Link Training Timer Update for D2.1

(comments # 66, 418)

Figure 178B-10—Training control state diagram

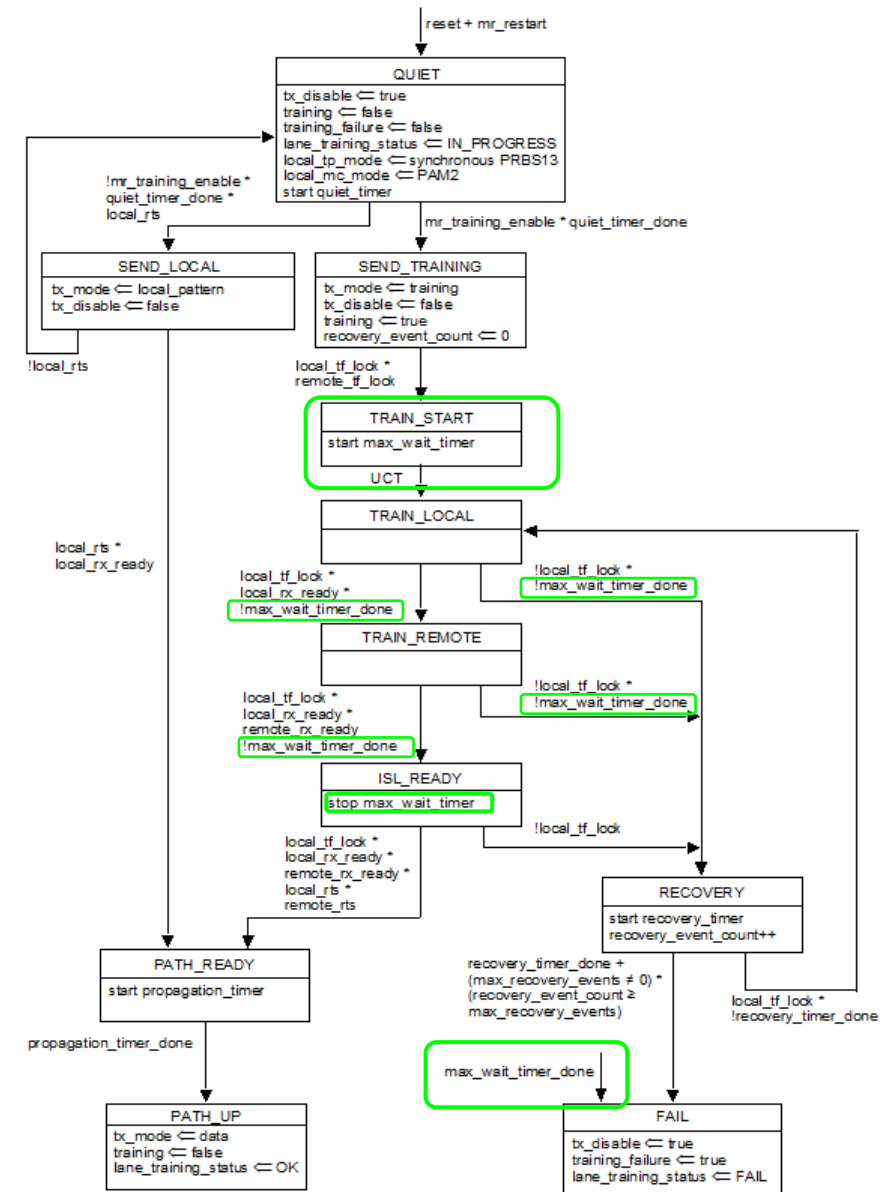
- Additions to the original diagram are highlighted in green.
- The new timer is started in new state TRAIN_START.
- The timer is active during TRAIN_LOCAL and TRAIN_REMOTE, and stopped in ISL_READY.
- Expiry before it is stopped causes transition to FAIL.

- 178B.7.3.3 max_wait_timer
 - This timer is started when the training control state machine enters the TRAIN_START state (see Fig 178B-10). The terminal count of this timer is max_wait_timer_duration variable in seconds +/- 0.1% (see Table 178B-6). The default duration is specified by the AUI component or PMD. When the max_wait_timer_duration is set to 0, the timer duration is infinite and max_wait_time_done always remains false.
- 178B.7.3.1 max_wait_timer_duration
 - Integer variable value that sets the duration of the max_wait_timer in seconds (See 178B.14.3.3). The default value is specified by the AUI component or PMD.
- 45.x.x.x.x ILT max_wait_timer_duration
 - 16b MDIO register (R/W) that sets the maximum duration for adapting the equalization of the link when transmitting the training pattern during ILT specified in Annex 178B.
 - Add to Table 178B-6 (the mapping table).
